FIELD CHANGE ORDER	Number: HSC70-I001
--------------------	--------------------

Applicability: The L0118 Rev B* module should be installed on all CI750, CI780, CIBCI, & HSCxx nodes used in VAXclusters of 6 (six) or more CI/HSC nodes connected to a common SC008 Star Coupler. L0118s should replace all L0100 Rev D* link modules; L0100 Rev E* can coexist with L0118s except in greater than 16 node environment.

Problem/Symptom: Clusters of 6 or more CI/HSC nodes on SC008 may exhibit CI-PATH NO_RSP or NAK, ARB-TIMEOUTS, and VC-CLOSURE. L0118 (& L0100 Rev E*) corrects adjacent-node collision & arb problems. * FIX DETAILS ON PAGE 2. *

SET L0100-E1 COMPATIBILITY JUMPER AS FOLLOWS:

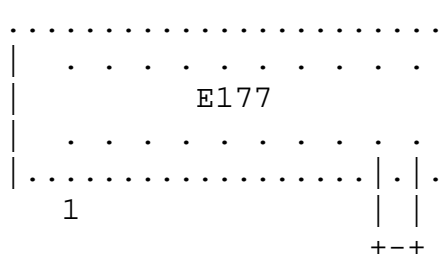
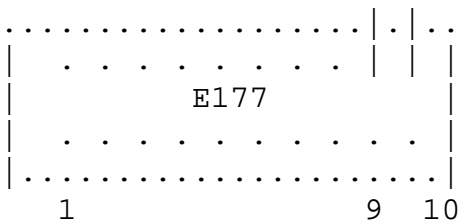
- o 7/10-TICK COMPAT. MODE SET BY 1 JUMPER @ E177 stake-pins.
 - "7-TICK COMPAT.-MODE": jumper E177-11 to E177-12
 - "10-TICK INCOMPAT.-MODE": jumper E177-9 to E177-10
- o NO CLUSTER-SIZE OR FUNCTION-MODE JUMPERS/SWITCHES.
- o L0100-E1 QUICK-CHECK (PART-REVISION VERIFY):
 - ECO wires at E177-13 and E177-9.
 - STAKE-PINS (for jumper) @ E177-9,10,11,12.
 - ETCH REV-C: P/N "50-14430C-0" marking.

"ECO-FIX OFF"
"7-TICK"
"COMPATIBLE"

"ECO-FIX ON"
"10-TICK"
"INCOMPATIBLE"
